PRODUCT/PROCESS CHANGE NOTICE (PCN)

PCN #: TB1311-01 Product Affected: VFQFPN-28, VFQFPN-40, VFQFPN-48 shipped in Tape & Reel (Refer to Attachment II for affected part#) Date Effective: July 9, 2014	DATE April 9, 2014	MEANS OF DISTINGUISHING CHANGED DEVICES: <input type="checkbox"/> Product Mark <input type="checkbox"/> Back Mark <input type="checkbox"/> Date Code <input checked="" type="checkbox"/> Other
--	---------------------------	--

ATTACHMENT I - PCN #: TB1311-01

Detail of Change: This notification is to advise our customers that IDT has qualified a new revision of carrier tape for package VFQFPN-28, VFQFPN-40 and VFQFPN-48.

Figure1: Illustration of Existing Carrier Tape Pocket and New Carrier Tape Pocket

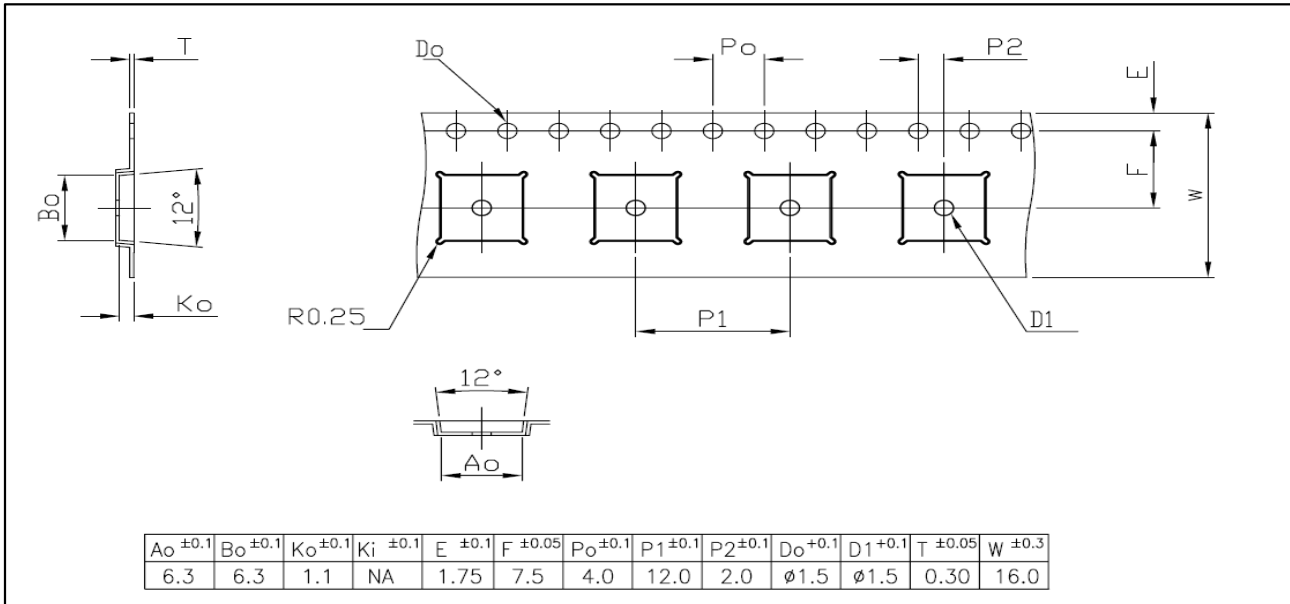
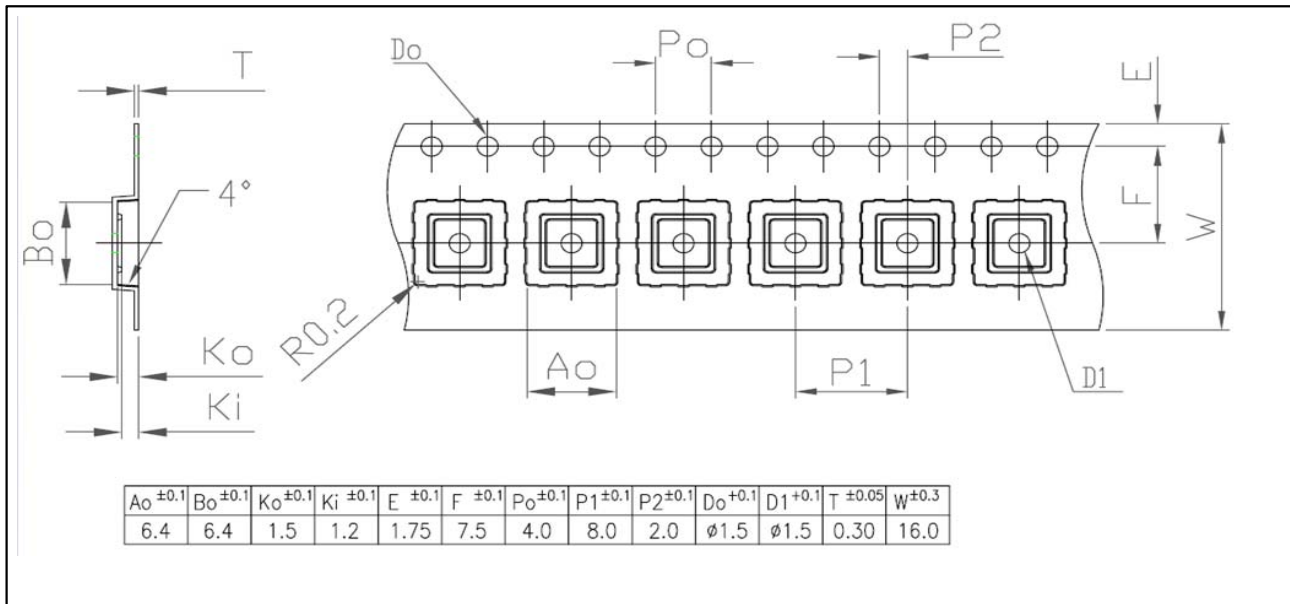
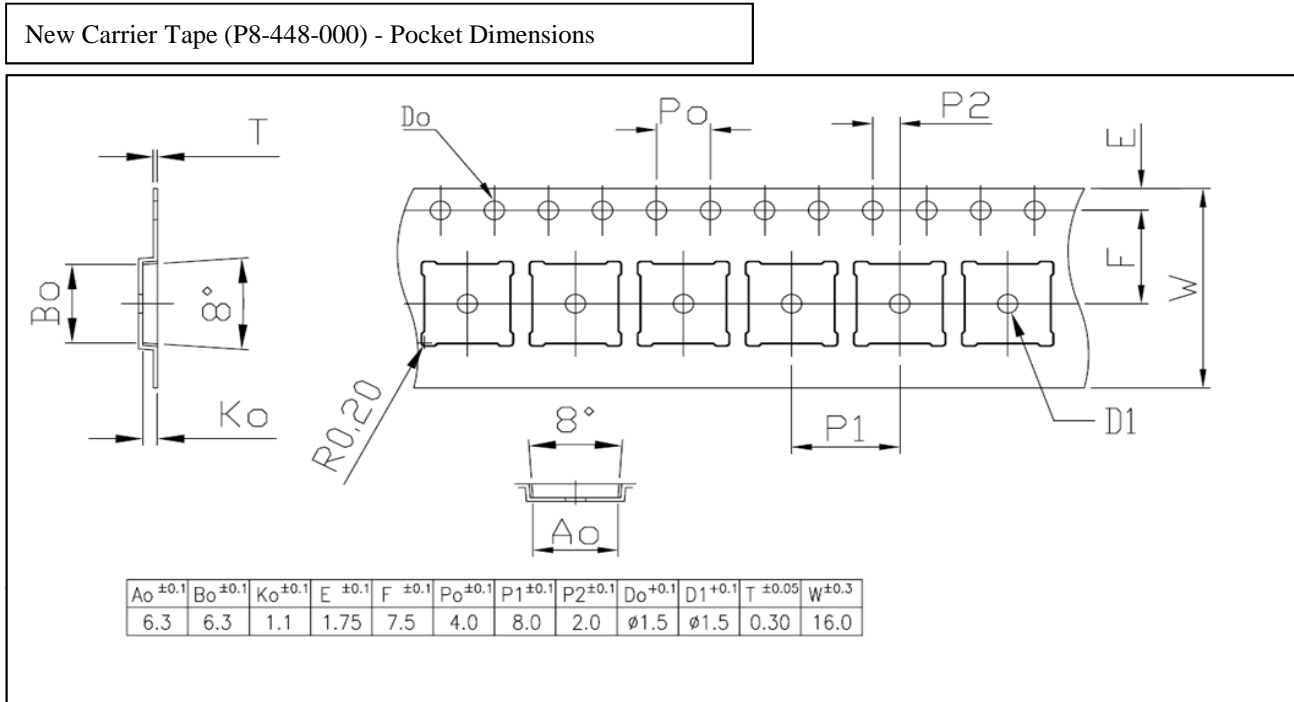
The new carrier tape has changes in pocket design and dimensions however quantity per reel remains unchanged.

Refer to to Table 2, Figure 1 and 2 for the comparison of the existing and new carrier tape in terms of carrier tape pocket dimensions and pocket designs respectively.
